Project Name: 793 Andrews Avenue

SITE PLAN REVIEW AND APPEARANCE BOARD STAFF REPORT

File No.: 2019-236-SPM-SPR-CL3

Application Type: Class III Site Plan Modification

PROPOSED SITE PLAN
SCALE: 1" = 10'-0"

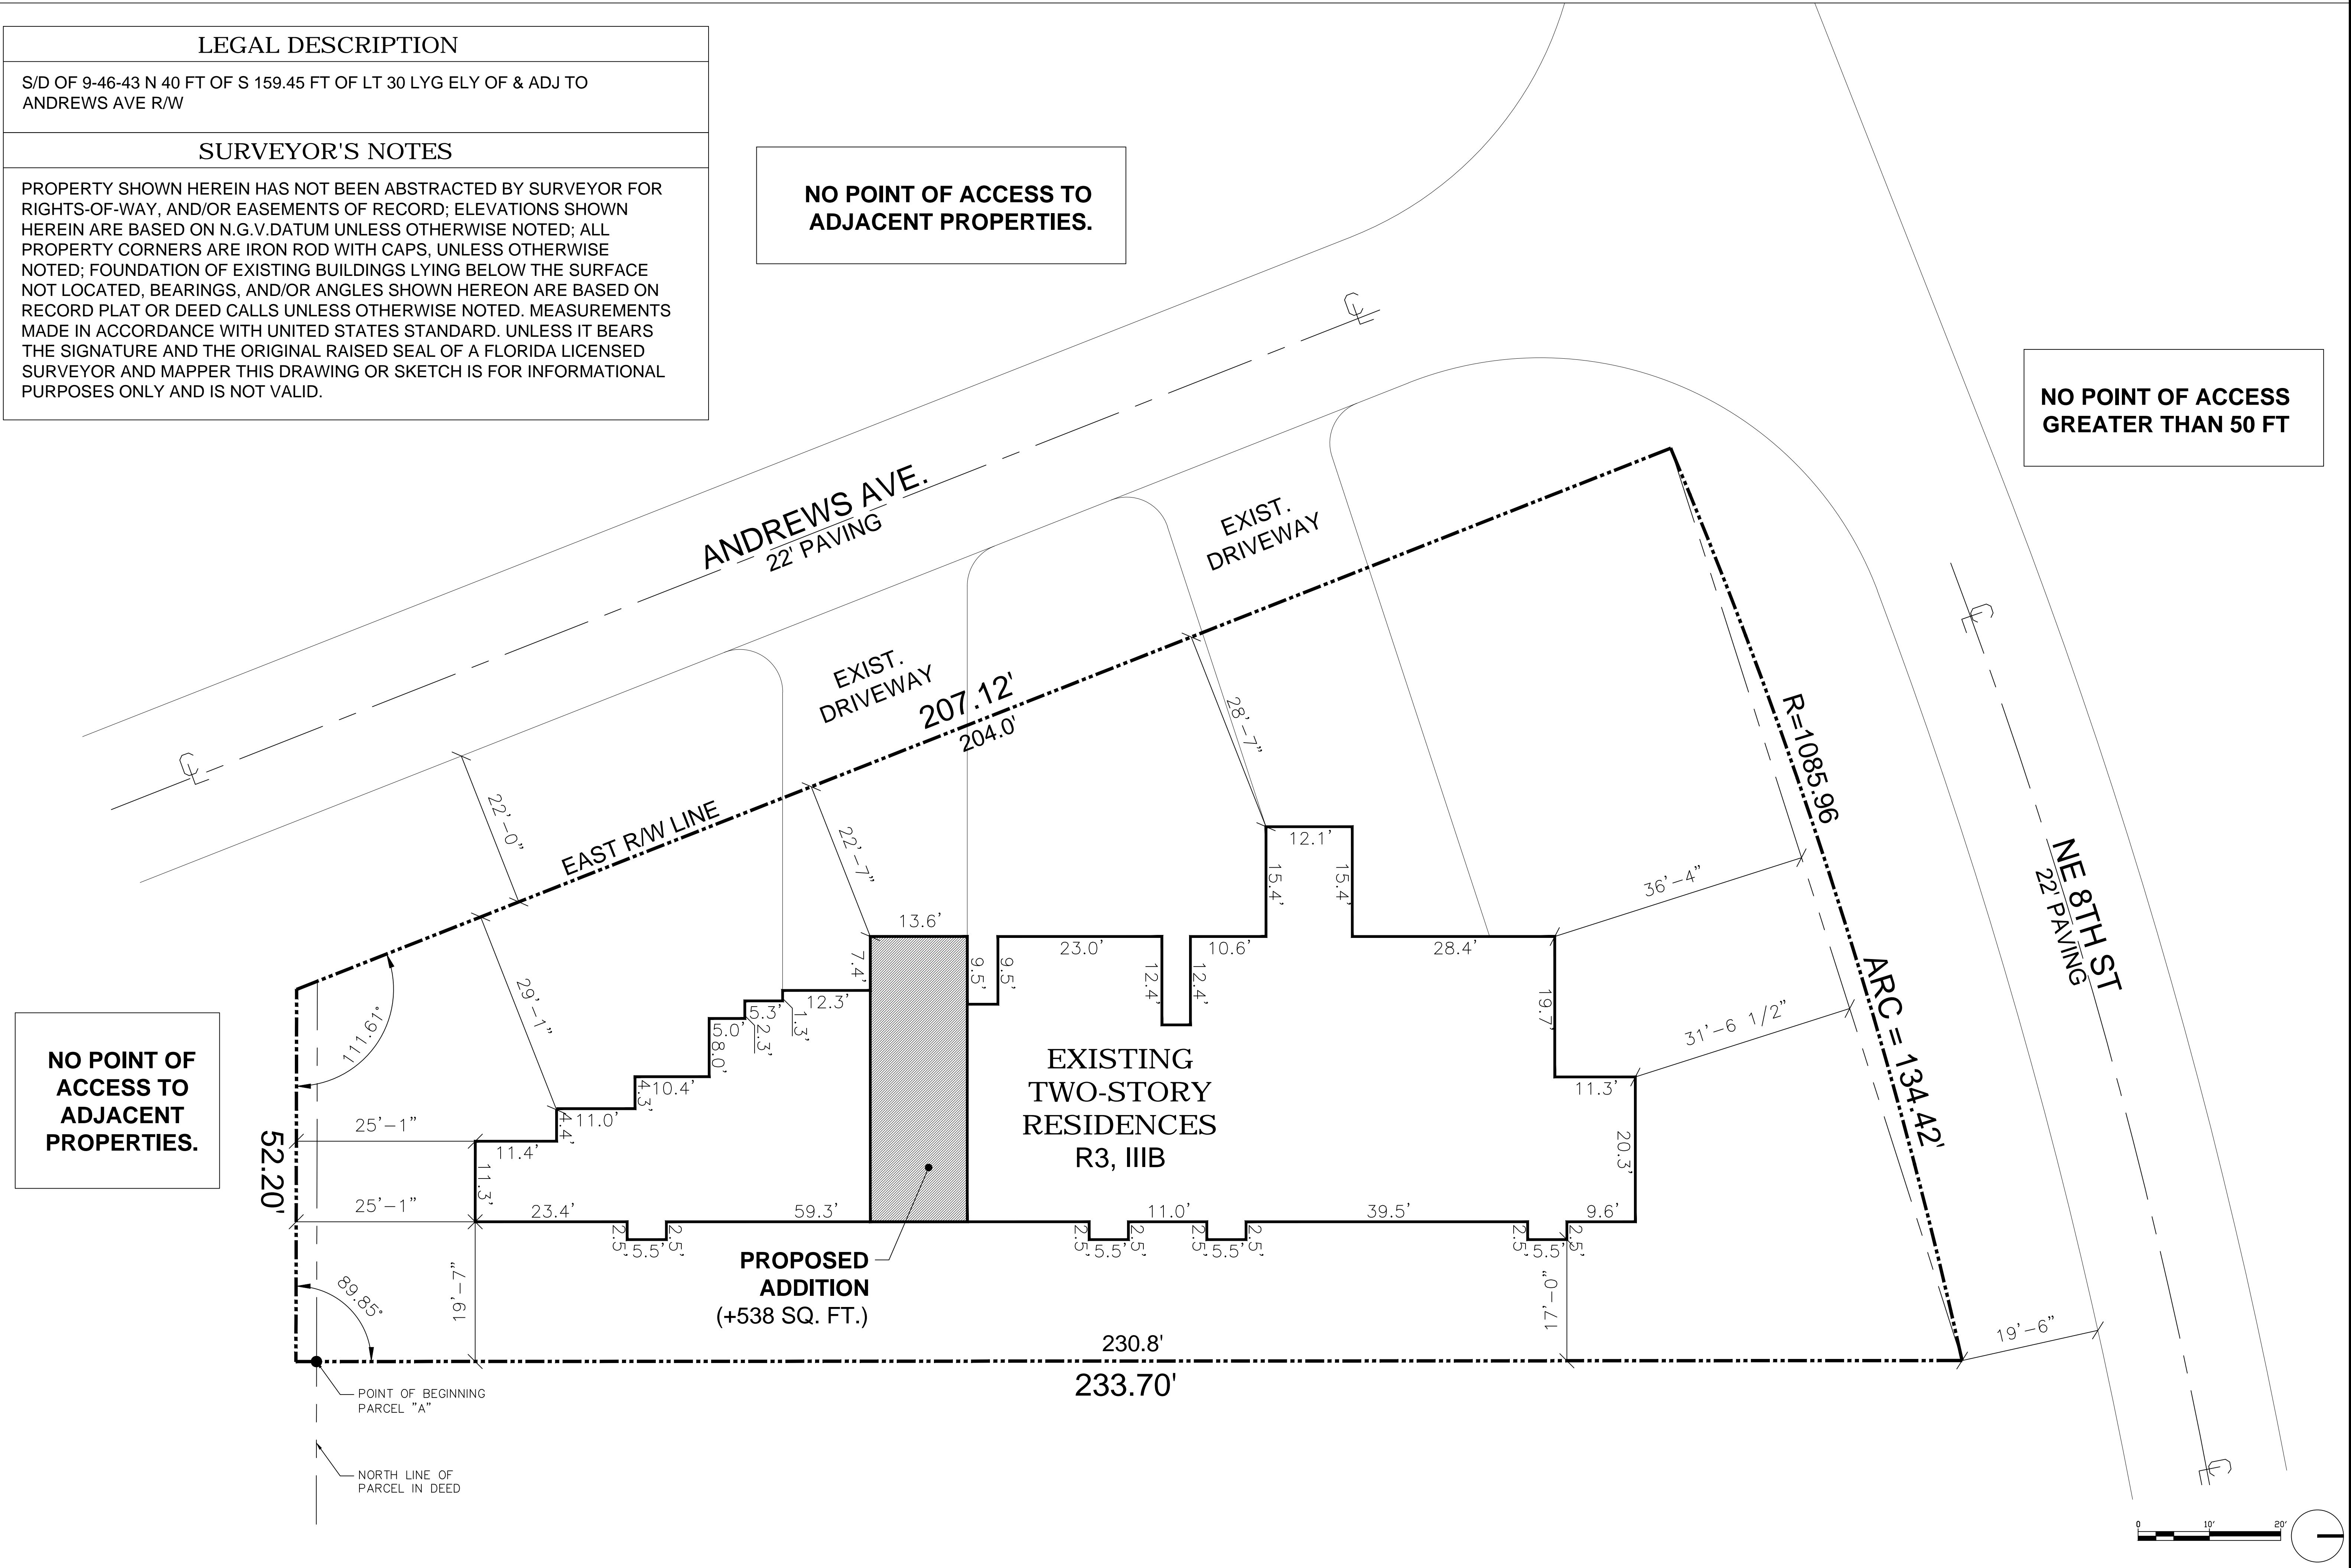
<u>Zoning</u> RM (Medium Density – Multiple Family Residential)	<u>Required</u> (1&2/3*)	<u>Proposed</u> (1&2/3*)
<i>Building Setbacks (min.):</i> Front (North/George Bush)	25'	31'-6 1/2 "
Side Interior (East)	15'	17'
Side Street (West/Andrews Avenue)	15'	22' 7"
Rear (South)	25'	25' 1"
<i>Building Height (max.):</i>	35'	22' 10"
<i>Minimum Floor Area for a 4 Bedroom unit:</i>	1,500 sf.	3,126 sf.

The adjacent zoning districts and uses are complimentary to the existing residential development. The proposed second-floor expansion will comply with the minimum setback requirements and should not represent a negative impact on the adjacent properties and uses.

PARTIAL FRONT ELEVATION
SCALE: 1/4" = 1'-0"

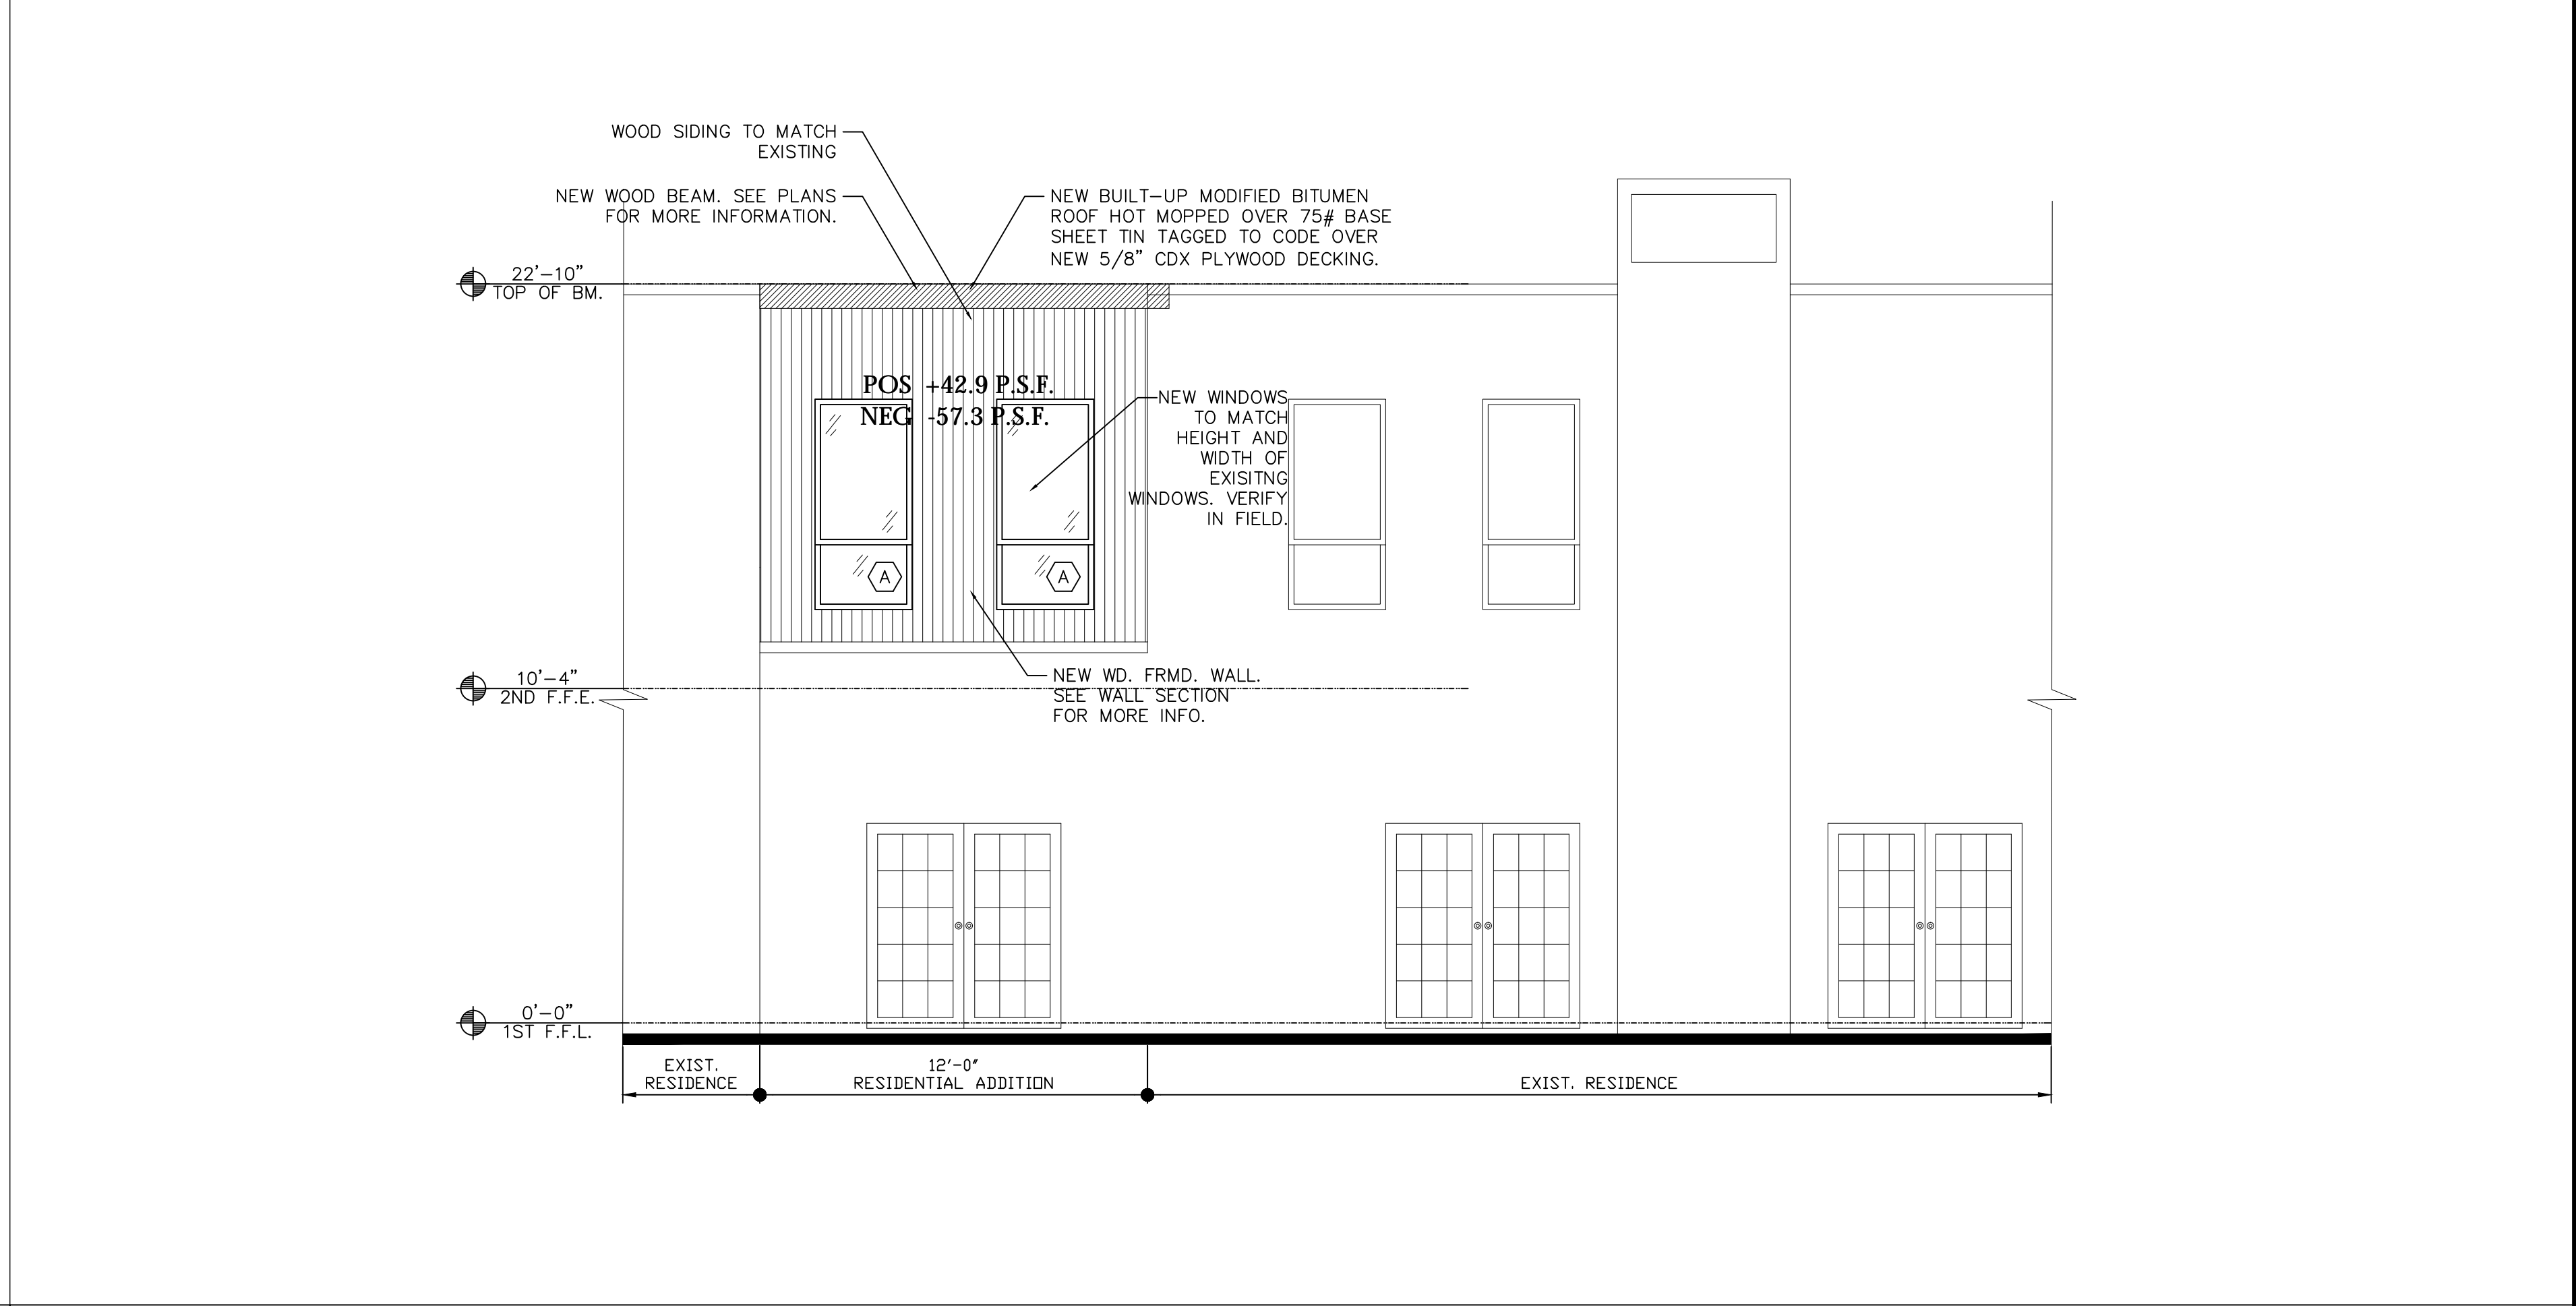
The proposed architectural elevation modification is associated with a 538 ft. addition on the second floor to accommodate two additional bedrooms and a bathroom. The second-story expansion will completely enclose the existing second level balcony above the garage. A set of three 1/1 single-hung windows is proposed on the west façade that faces Andrews Avenue, and two individual single-hung 1/1 windows are proposed on the east elevation. The proposed façade finish will match the existing wood finish.
